PCI-SIG ENGINEERING CHANGE NOTICE

TITLE:	TLP Prefix
DATE:	December 15, 2008
AFFECTED DOCUMENT:	PCIe Base Specification 2.0
SPONSOR:	Intel Corporation, AMD, HP, NextIO

Figure 2-3: Generic TLP Format

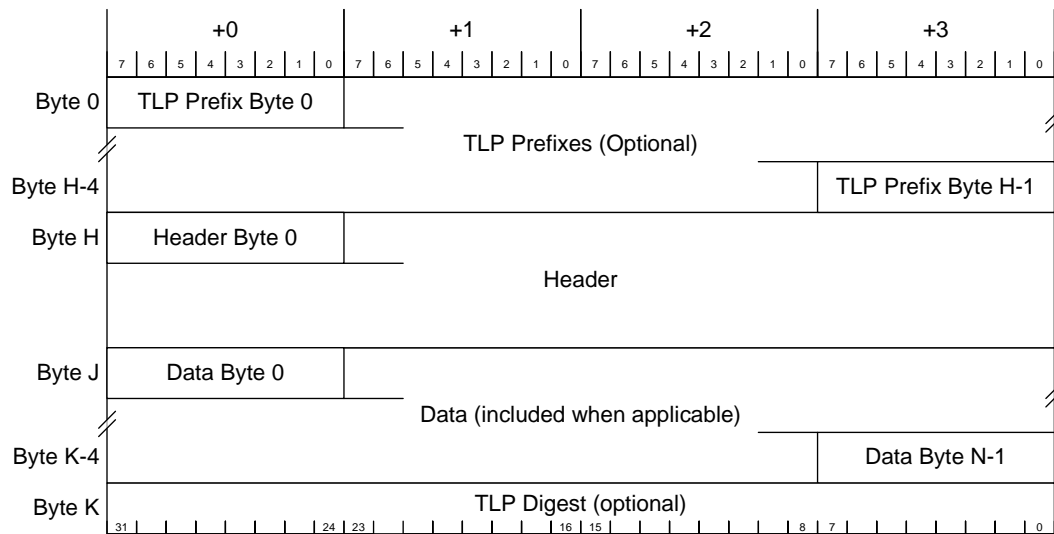
Detailed layouts of the TLP Prefix, TLP Header and TLP Digest (presented in generic form in Figure 2-3) are drawn with the lower numbered bytes on the left rather than on the right as has traditionally been depicted in other PCI specifications. The header layout is optimized for performance on a serialized interconnect, driven by the requirement that the most time critical information be transferred first. For example, within the TLP header, the most significant byte of the address field is transferred first so that it may be used for early address decode.

Payload data within a TLP is depicted with the lowest addressed byte (byte J in Figure 2-3) shown to the upper left. Detailed layouts depicting data structure organization (such as the Configuration Space depictions in Chapter 7) retain the traditional PCI byte layout with the lowest addressed byte shown on the right. Regardless of depiction, all bytes are conceptually transmitted over the Link in increasing byte number order.

7.10 Advanced Error Reporting Capability

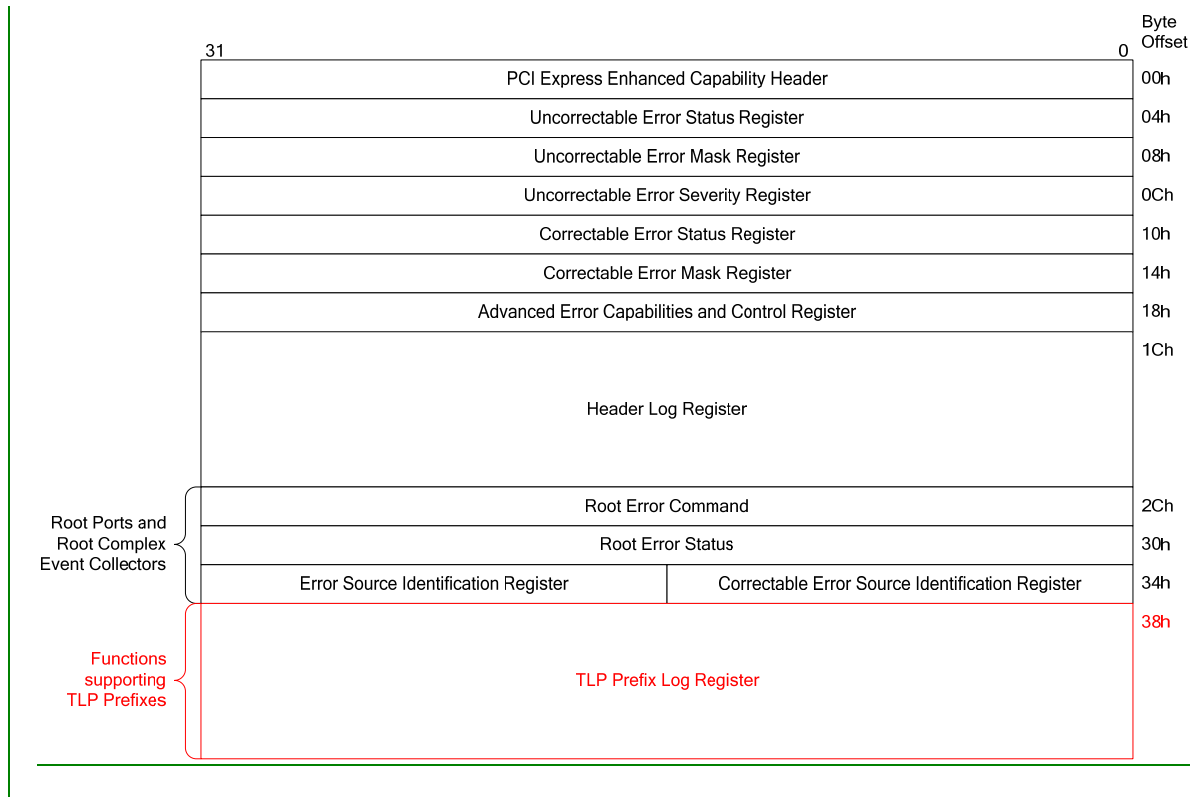
Add TLP Prefix Log to Figure 7-30 (for the ECN, this is shown in red).

Figure 6-1: Header Log Register

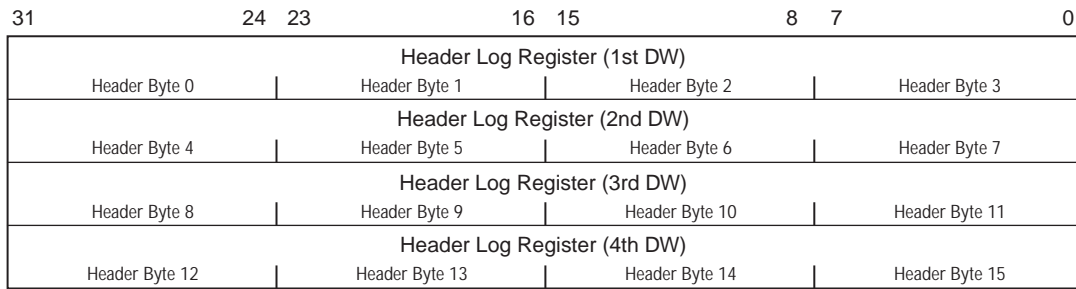
In certain cases where a Malformed TLP is reported, the Header Log Register may contain TLP Prefix information. See Section 6.2.4.4 for details.

Figure 7-xx TLP Prefix Log Register

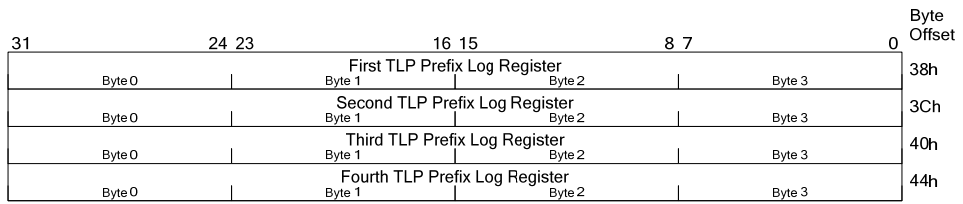
The TLP Prefix Log register captures the End-End TLP Prefix(s) for the TLP corresponding to the detected error; refer to Section 6.2 for further details. The TLP Prefix Log register is only meaningful when the TLP Prefix Log Present bit is Set (see Section 7.10.7).

The TLP Prefixes are captured such that, when read using DW accesses, the fields of the TLP Prefix are laid out in the same way the fields of the TLP Prefix are described. Therefore, byte 0 of a TLP Prefix is located in byte 3 of the associated TLP Prefix Log register, byte 1 of a TLP Prefix is located in byte 2 and so forth.

The First TLP Prefix Log Register contains the first End-End TLP Prefix from the TLP (see Section 6.2.4.4). The Second TLP Prefix Log register contains the second End-End TLP Prefix and so forth. If the TLP contains fewer than four End-End TLP Prefixes, the remaining TLP Prefix Log Registers contain zero. A TLP that contains more End-End TLP Prefixes than are indicated by the Function's Max End-End TLP Prefixes field must be handled as a Malformed TLP (see Section 2.2.10.2). To allow software to detect this condition, the supported number of End-End TLP Prefixes are logged in this register, the first overflow End-End TLP Prefix is logged in the first DW of the Header Log register and the remaining DWs of the Header Log Register are undefined (see Section 6.2.4.4).

The TLP Prefix Log Registers beyond the number supported by the Function are hardwired to zero. For example, if a Functions, Max End-End TLP Prefixes field contains 10b (indicating 2 DW of buffering) then the third and fourth TLP Prefix Log Registers are hardwired to zero.
